Access Compliance Report

Public Rights-of-Way

Intersection ID: 53624	Main Street: PROSPERITY RIDGE RD	Cross Street: RIDGE RD	Location: NE
ADA ID: B97C6E7D1A36	Ramp Type: Perp	Initial Pass/Fail: Fail	Overall Compliance: No
Severity Score: 13.75			
Codes/Mitigation Info/Possible Solution		Field Measurements/Component Compliance

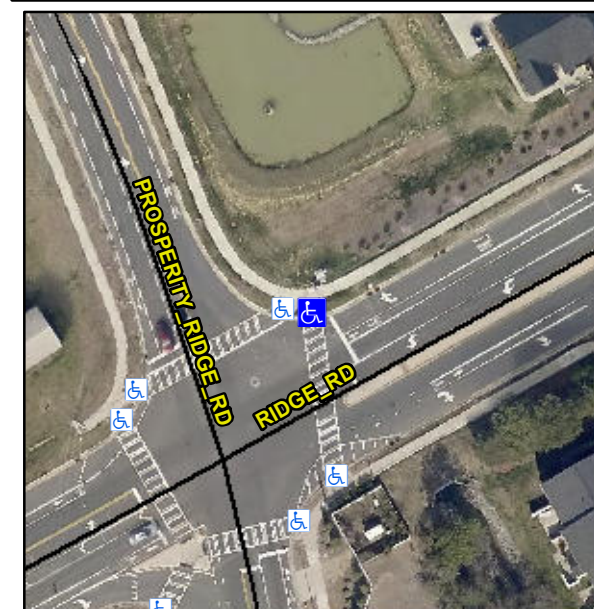
R304.2.2, R304.5.3

Compliance	Description	Data	Compliance	Description	Data
N/A	Ramp Length (in)	105.0	No	Ramp Slope (%)	8.9
Yes	Ramp Width (in)	67.0	No	Ramp XSlope (%)	4.9
N/A	Flare Type LT	N/A	N/A	Flare Type RT	N/A
N/A	Flare Slope LT (%)	N/A	N/A	Flare Slope RT (%)	N/A
N/A	Flare Traversable LT?	N/A	N/A	Flare Traversable RT?	N/A
N/A	Landing Length (in)	N/A	N/A	DWS Provided?	N/A
N/A	Landing Width (in)	N/A	N/A	DWS Contrast?	N/A
N/A	Landing Slope (%)	N/A	N/A	DWS Length (in)	N/A
N/A	Landing X Slope (%)	N/A	N/A	DWS Full Width?	N/A
N/A	Landing Curb? (Y/N)	N/A	N/A	DWS Offset (in)	N/A
N/A	Shared Landing?	N/A			
N/A	Gutter Ponding?	N/A	N/A	Gutter Slope (%)	N/A
N/A	Gutter Lip Ht (in)	N/A	N/A	Gutter X Slope (%)	N/A
N/A	Painted X Walk1?	Yes	N/A	Painted X Walk2?	N/A
	X Walk 1 Direction	To S		X Walk 2 Direction	N/A
N/A	X Walk 1 Width (in)	111.5	N/A	X Walk 2 Width (in)	N/A
	X Walk 1 Slope (%)	1.1		X Walk 2 Slope (%)	N/A
	X Walk 1 X Slope (%)	3.3		X Walk 2 X Slope (%)	N/A

Remove & Replace Entire Ramp.
